City of Denton

Meeting Agenda Planning and Zoning Commission

Wednesday, May 13, 2026

- A. [FP26-0012b](#) Consider a request by Mack Mattke of Kimley Horn & Associates on behalf of CATDENTON 35 for a Final Plat of Summit 35 Addition. The approximately 68.175-acre property is generally located east of North Interstate 35, north of Loop 288, and southwest of Highway 77 (North Elm Street) in the City of Denton, Denton County, Texas. (FP26-0012b, Summit 35, Julie Wyatt)

MATCH LINE SHEET 10

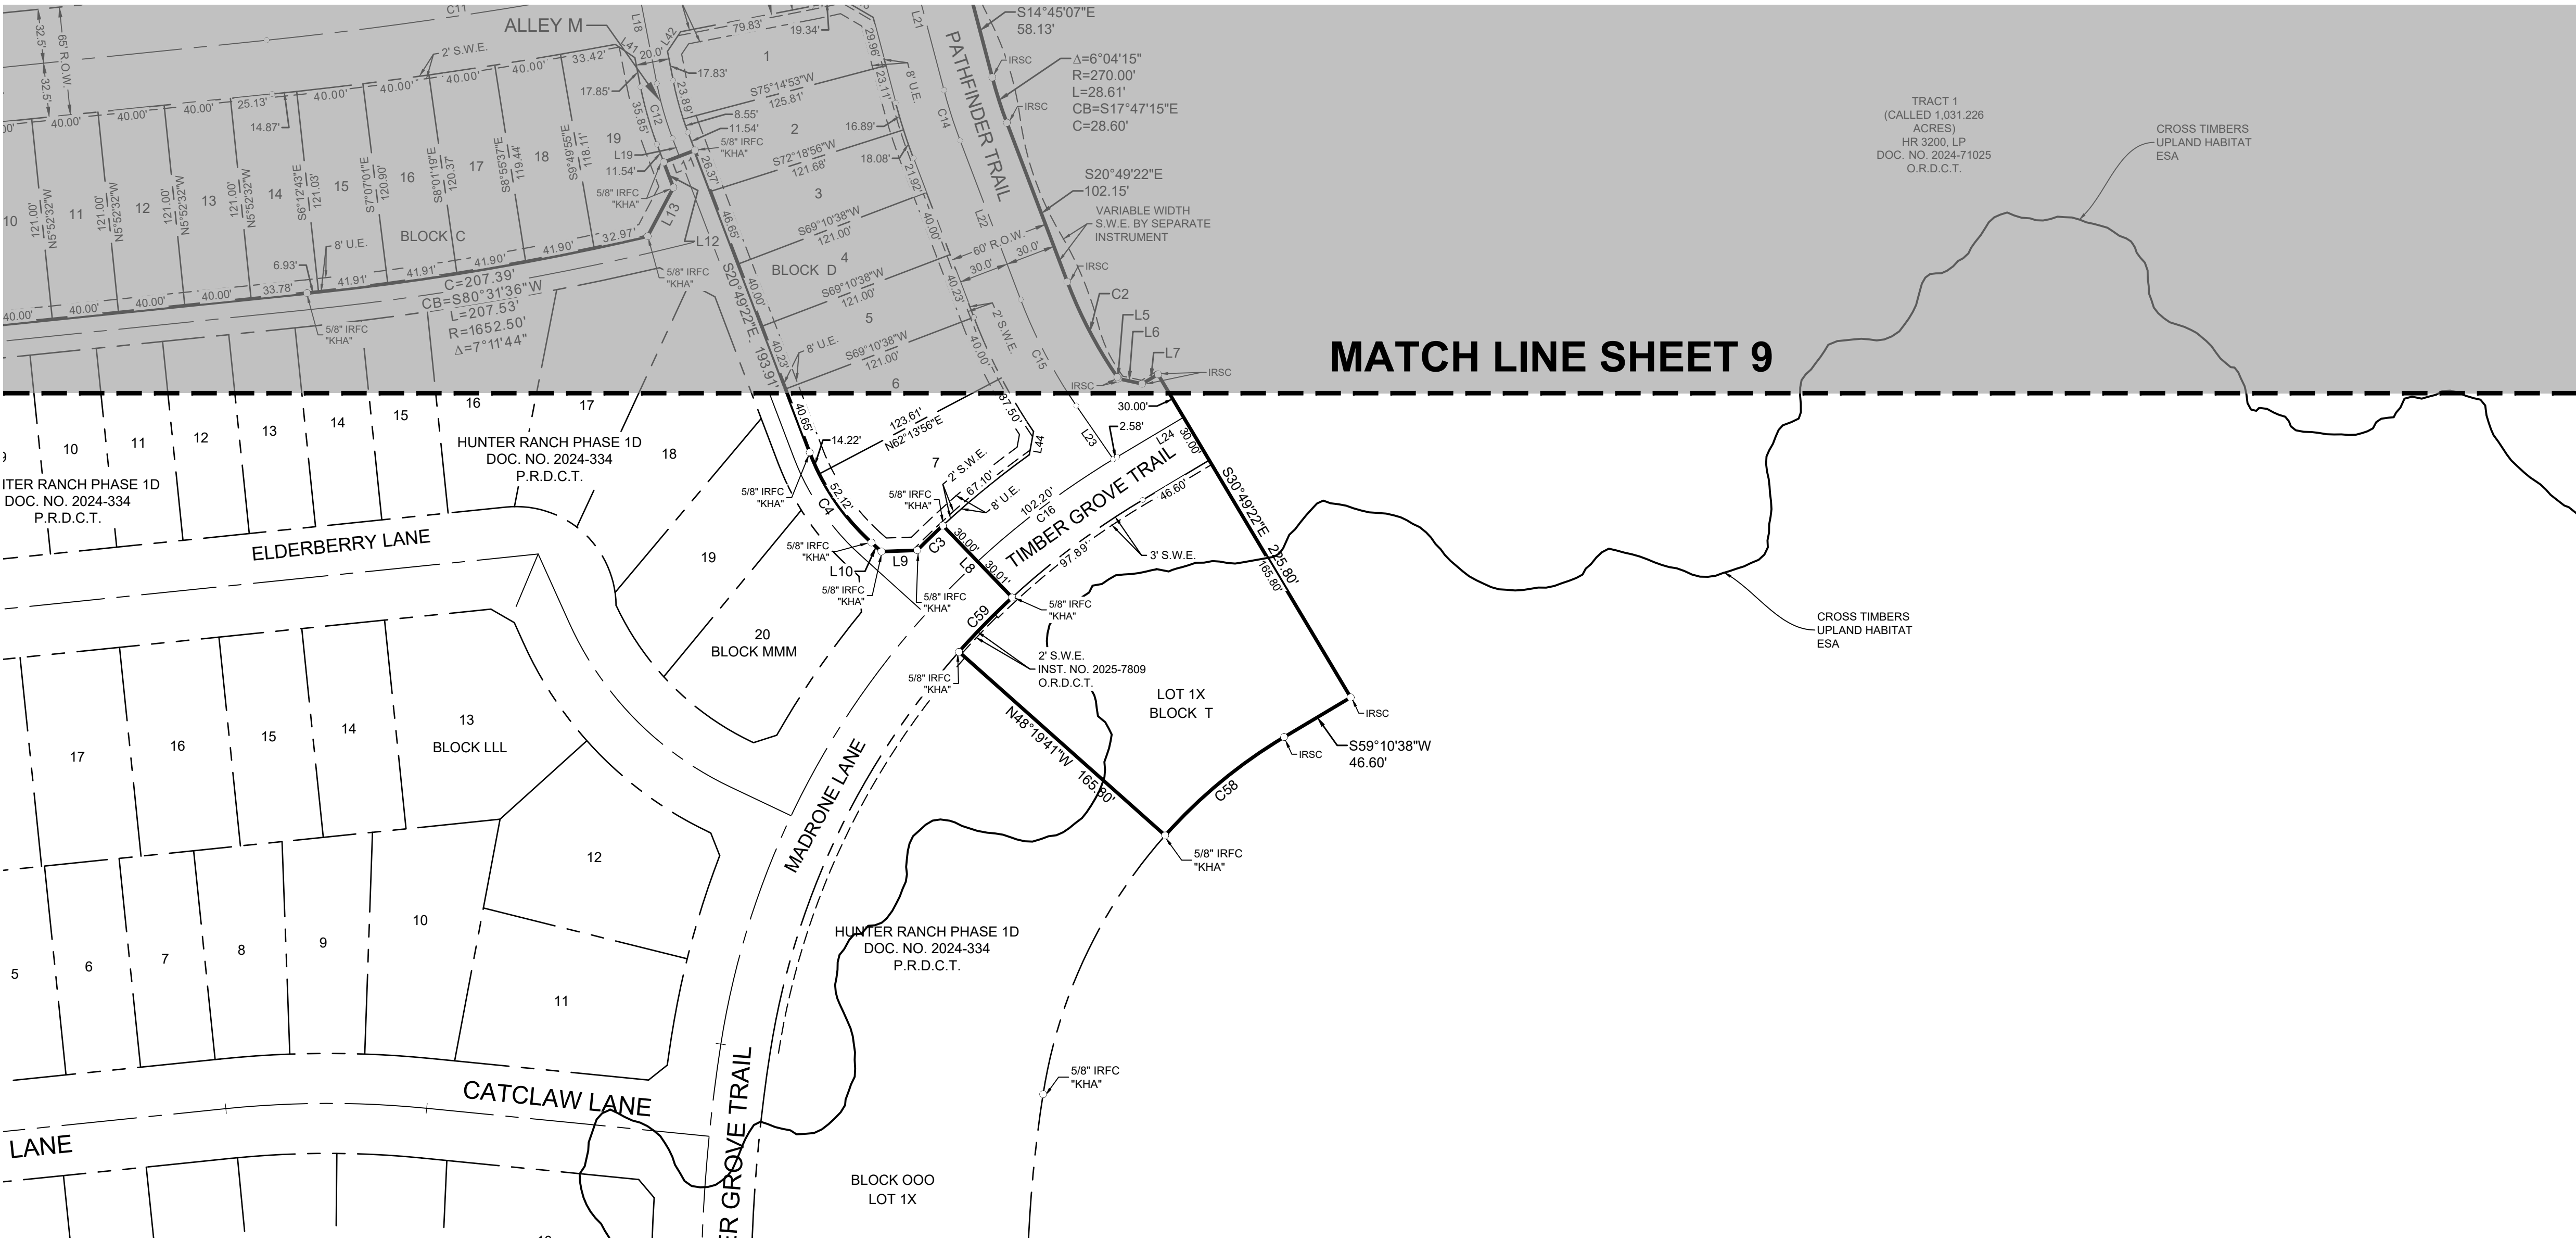
1. Compliance with MPC19-0002c 2.11.4C.2.d, which requires final approval of the Civil Engineering Plans (CEP25-0082), must be achieved prior to final approval.

1. Compliance with MPC19-0002c 2.11.4C.2.d, which requires final approval of the Civil Engineering Plans (CEP25-0082), must be achieved prior to final approval.

4. Compliance with this DDC				
a. The proposed development shall comply with all applicable standards in this DDC, unless the standard is to be lawfully modified. Findings:		☐	☒	☐
